# UNITED STATES PATENT AND TRADEMARK OFFICE

10/591,126

<b>Office Action Summary</b>	<b>Application No.</b> 10/591,126	<b>Applicant(s)</b> THOMASSET, JACQUES	
	<b>Examiner</b> ERIK KASHNIKOW	<b>Art Unit</b> 1794

## **DETAILED ACTION**

#### **FIG. 1A**

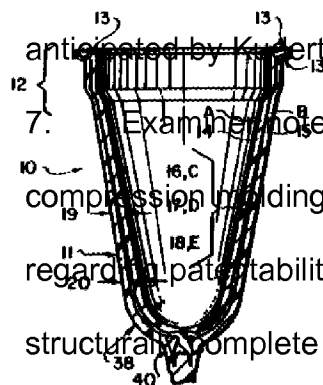
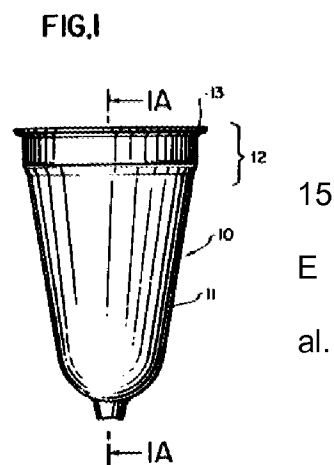
9. In regards to claims 1 and 5 Kudert et al. teach a parison (which correlates to Applicant's Dose), which comprises 2 outer layers which may or may not be the same (column 27 lines line 48- column 28 line 1), and 3 inner layers, one being a barrier layer and the other two, on either side of the barrier layer are adhesive layers (column 27 line 48 column 28 line 19).

Figures 1 and 1A show an example of this parison, and indicate that it would have an axis of symmetry, with 14 and representing the outer layers, C the barrier layer, and D and the other two on the other side of the barrier layer. Kudert et teach that the parisons are formed by injection molding (column 35 line 65 column 36 line 15), and is silent with regards to any compression molding taking place, as such, the parisons of Kudert et al. meet the limitation of a concave surface being present prior to any compression molding.

10. In regards to claims 2 and 4 Figures 1 and 1A show that the parison has a concave surface, which has an opening which acts as the orifice (where an orifice is defined by dictionary.com (<http://dictionary.reference.com/browse/orifice>) as a mouth like opening or hole also Figs. 1 and 1A). It is also pointed out that Kudert et al. teaches that these parisons are formed by Injection molding, which involves heating the

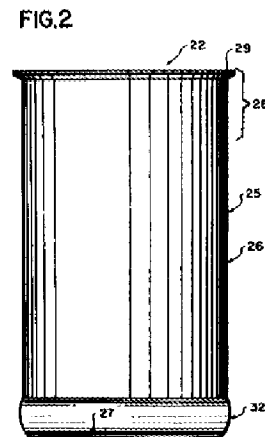
13. In regards to claim 6 Kudert et al. teach an embodiment wherein the article is a can shaped container (Fig. 2), and teach that the barrier layer (in this case the functional layer) has a fold in it (Fig 6 and 7).

15. In regards to claim 8 and 9 Fig 2 is an open container, and as shown in Fig 2 the opening, as it is in can shaped objects, is centered around the axis of symmetry (Fig. 2 and column 19 lines 37-38), and therefore the body of revolution is open.

16. In regards to claims 11 and 12, Fig. 2A shows an embodiment wherein the object is closed by a cap, which eliminates the orifice, and makes the object closed around the axis of symmetry (Fig. 2A and column 19 lines 39-40).
